**Monks Orchard
Residents' Association
Planning**

25th January 2022

| Reference: | 21/05950/FUL |
| Proposal: | Demolition of an existing detached dwelling and construction of a new three storey building comprising 8 apartments with associated private and communal amenity space, refuse and cycle storage |

**Proposed re-development illustration at 44 Orchard Avenue
as viewed from the rear garden of Holbrooke Court, 40 Orchard Avenue .**

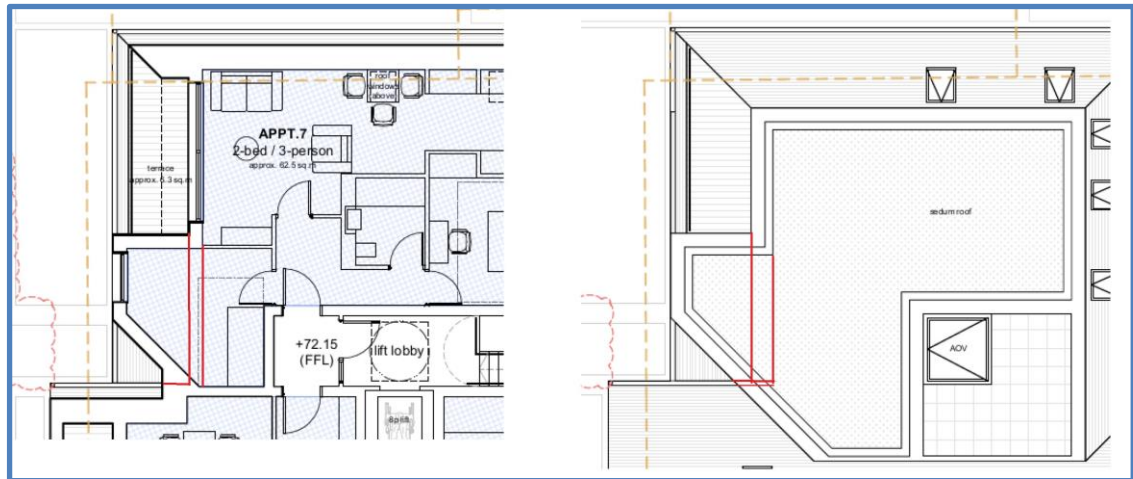
2.3 The illustrations above do not reflect the Design and Access Statement quote at Item 3.5 - Materials which states:

"Contrasting darker Tiles are proposed to distinguish between the wall hung and those used on the roof to help break-up and separate into three layers ..."

This requirement needs to be ensured and emphasised in conditions if the Case Officer is minded to approve the proposal as the illustration indicates a continuous colour material of brickwork and tiles from ground level elevation to roof-top which does NOT respect the local character whatsoever.

2.5 Separation:

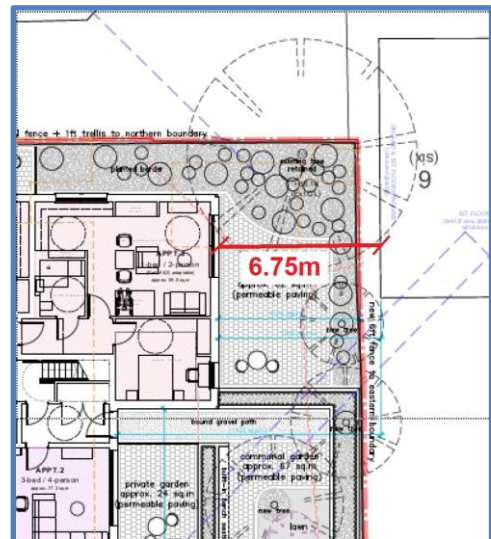
The separation distance between **No 6 Potters Close** as measured from the supplied plans, is only **≈6.75m**. It is not known if **6 Potters Close** has a facing window opposite the Apartment 3 Lounge. However, this proximity with **No. 6 Potters Close** is unsatisfactory with regard to overlooking and invasion of privacy to the occupants of **6 Potters Close** and is considered inappropriate for the **Design Code** relationships for spacing, in this locality. This reduced separation does **NOT** respect the existing separation of **≈12m** from the rear elevation of **44 Orchard Avenue** to the flank elevation of **6 Potters Close**.

Google Image of 800m radius from 44 Orchard Avenue showing that it is over 800m from Tram/Train Station and District Centre

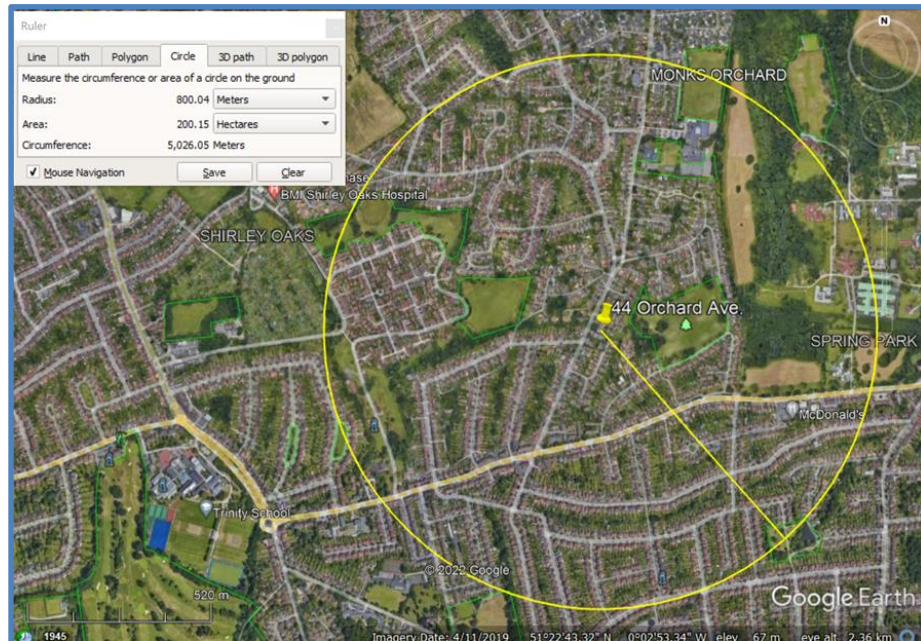
- 4.2.1 **44 Orchard Avenue has PTAL of 2 and is greater than 800m from a Tram/Train Station or District Centre and as such is inappropriate for incremental intensification.**

- 4.2.2 44 Orchard Avenue has a PTAL of 2 forecast to remain at 2 until at least 2031. Therefore, as the location is greater than 800m from a Tram/ Train Station or District Centre, the site is inappropriate for “incremental” intensification.
- 4.2.3 If the case officer is minded to recommend approval, we request detailed ‘justification’ for allowing the proposed ‘intensification’ in terms of Housing and Residential Density for this proposal at this Setting and PTAL which is in contradiction to the London Plan Policy H2 at para 4.2.4 and the London Plan Policy D3 and “Design Code” and the Department for Levelling Up, Housing and Communities “National Model Design Code and Guidance”.

CRO 7NA Post Code approximate Area at 1.97hectares

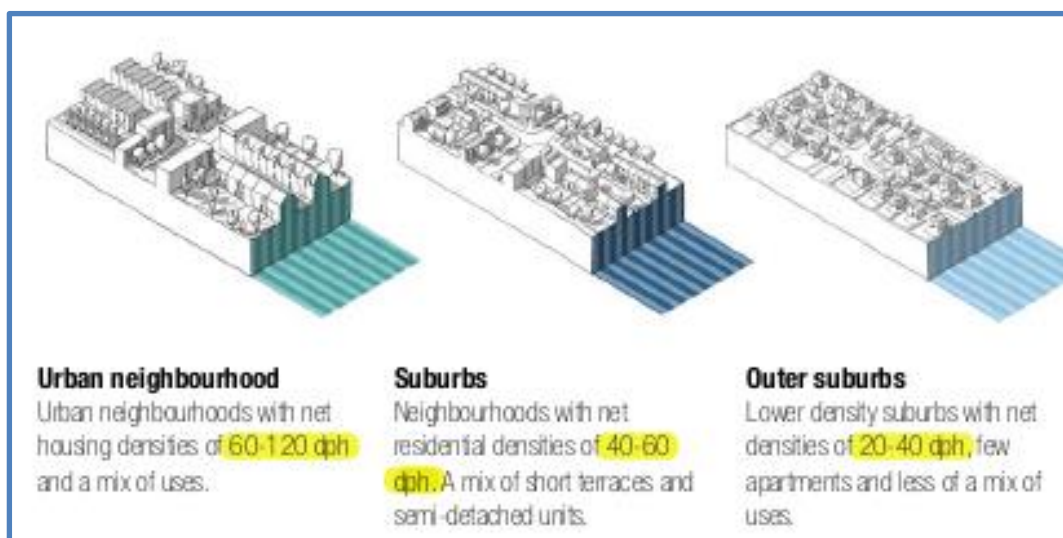
- 5.1.3 The Post Code Area **CR0 7NA** has a current **population** of **36** Housed in **18 Dwellings** in an approximate Area of **≈1.97hectare** which equates to a **Housing Density** of **9.14Units/ha** and a **Residential Density** of **18.27 persons/ha**. Which places the Post Code in an 'Outer Suburban' Design Code Setting.

Determination of Local Area Design Code Settings from evaluated data

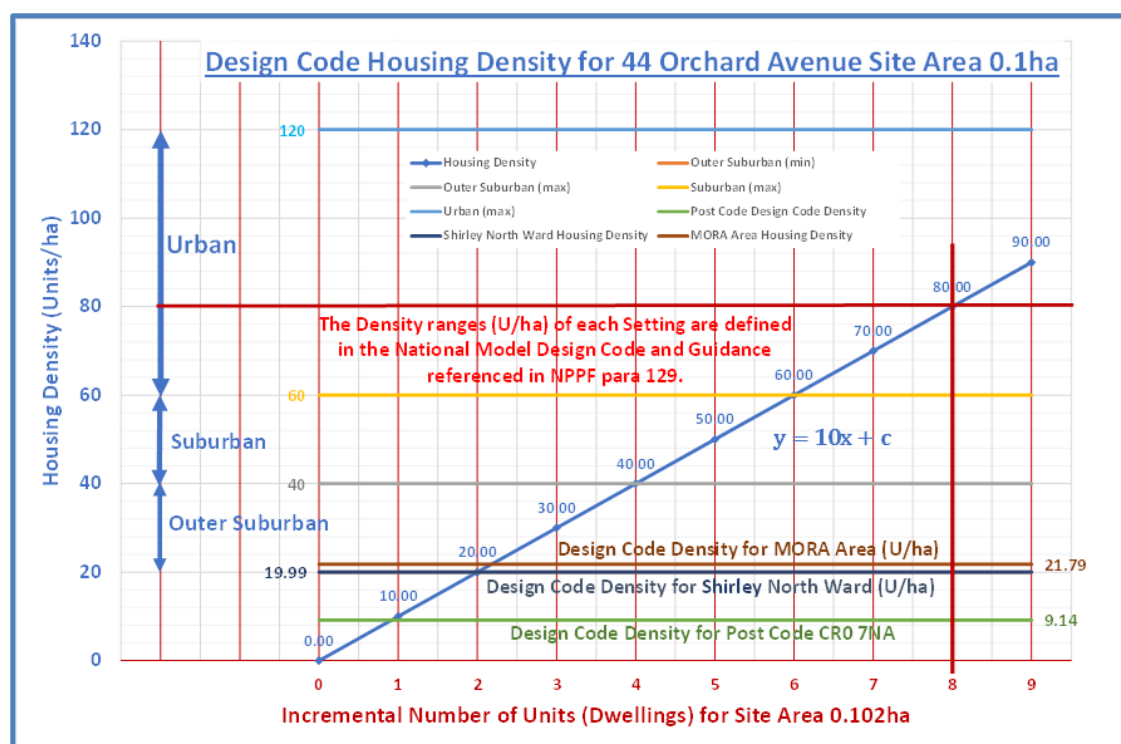
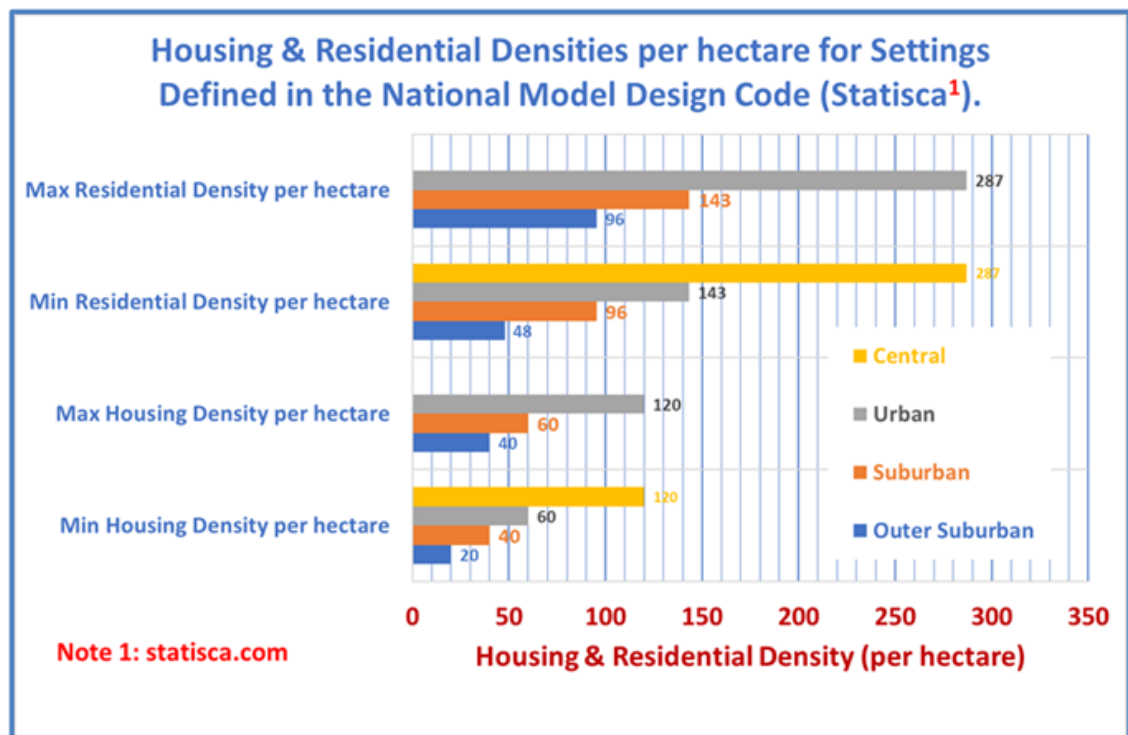
Design Code Analysis for the various local areas shows all < or within “Outer Suburban” Settings whereas the proposal would require an Urban Setting.

- 5.1.7 The graphical illustration above plots the **Design Code Housing Density (Units/ha)** over the range **0 to 9 dwellings** for the **Site Area (0.1ha)** of **44 Orchard Avenue**, against various examples of **Design Codes** of the local Areas to show that the prevailing

Design Code 'Setting' for the locality is **well within** the prescribed parameters for "**Outer Suburban**" (or Outer London Suburban) Setting.

5.1.8 **Shirley is definitely NOT Urban** as defined in the current adopted **Local Plan**, the Shirley "**Place**". At 80 Units/ha appropriate for an "**Urban**" Setting, this proposal is clearly an over development for the locality average Design Code '**Outer Suburban**' Setting.

Conversion of Housing Density ranges per Setting to Residential Densities

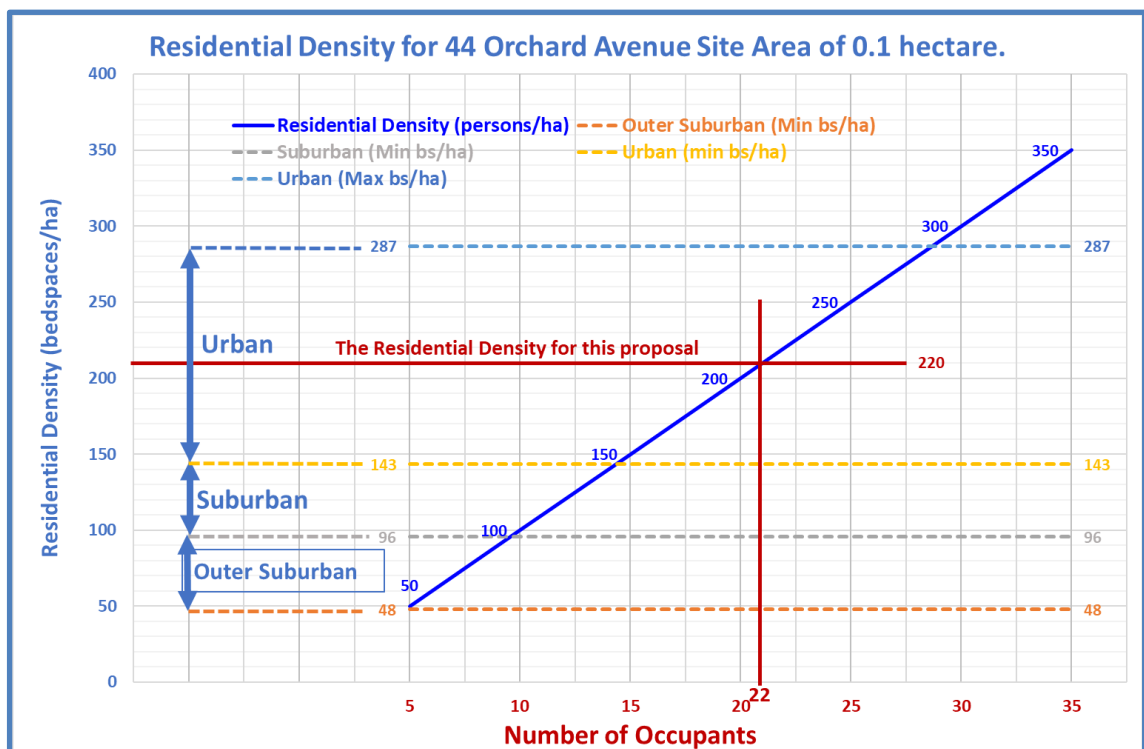
5.2.1 It is people who require supporting infrastructure, **NOT** Dwellings, so we need to establish equivalent **Residential Densities** ranges for the '**Settings**'. This can be achieved using the **Office of National Statistic's** data and **Statista**⁹ data. In 2020, the average number of people per household in the United Kingdom was **2.39** compared with 2.37 in the previous year. We can use this as a factor to convert equivalent Units/ha to Bedspaces/ha as shown in the following Graphical illustration.

Residential Densities for Site Capacity for 44 Orchard Avenue relating Number of occupants and the equivalent National Model Design Code Settings.

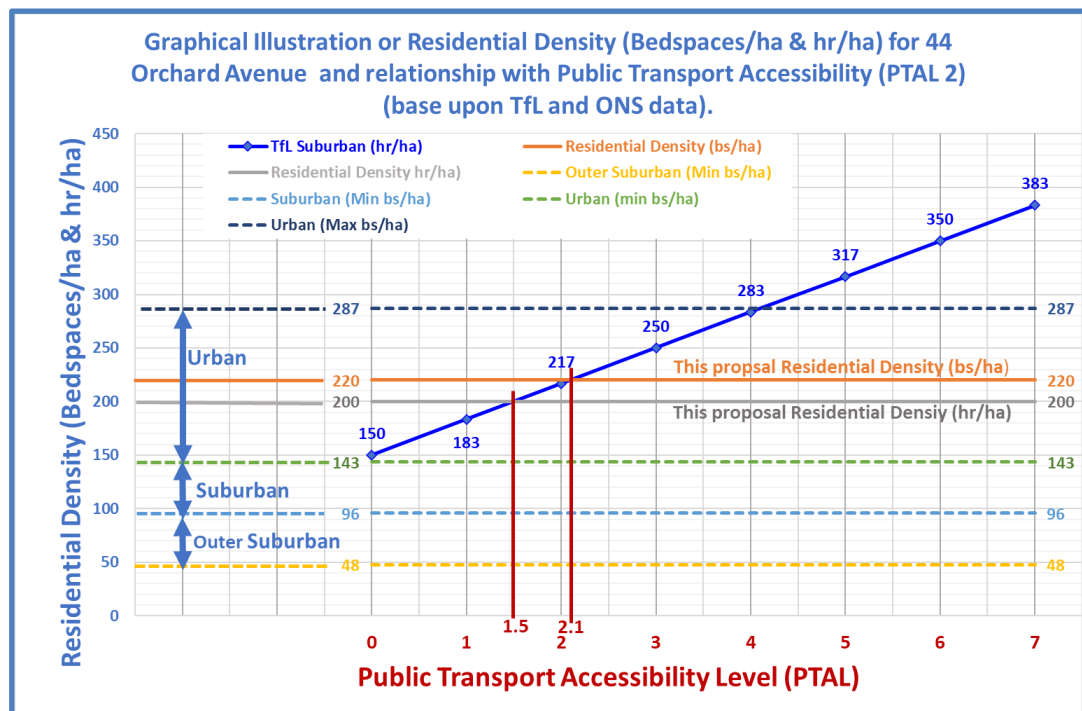
- 5.2.4 The evaluation of this proposal places 44 Orchard Avenue in an Urban Setting when all other assessment of the locality is either <Outer Suburban or Outer Suburban Settings with 8 dwellings at Housing Density of 80Units/ha clearly within the mid-range of an 'Urban' 'Setting' whereas the locality by the various local Area evaluations is well within or even below the Outer-Suburban Design Code 'Setting'. Additionally, at a Residential Density of 220 Bedspaces/ha or 200 hr/ha Residential Density confirms the capacity requires an 'Urban' Setting whereas the actual Setting is 'Outer Suburban'.

- 5.2.5 The above analysis also **confirms** the **Public Transport Accessibility (PTAL)** for the **Residential Density** is acceptable within the capacity of **PTAL 2**.
